Product: **Fault Monitoring Unit**

Type: **SMB/S 1.1**

Current application program: **Fault Signal 1.1b**

Software-Information	to:	Fault signal 1.1b
	from:	01/2021

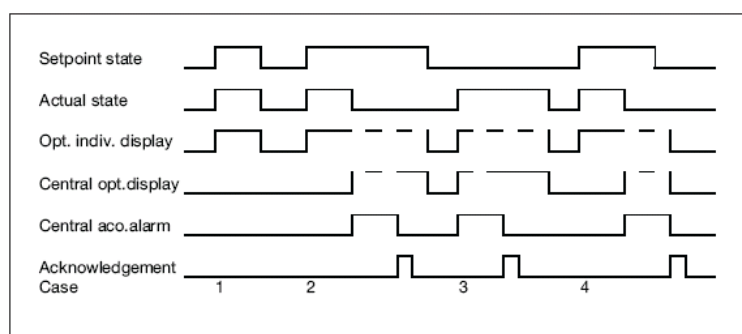
2. Initial value signal with simple acknowledgement:

The following diagram was adapted
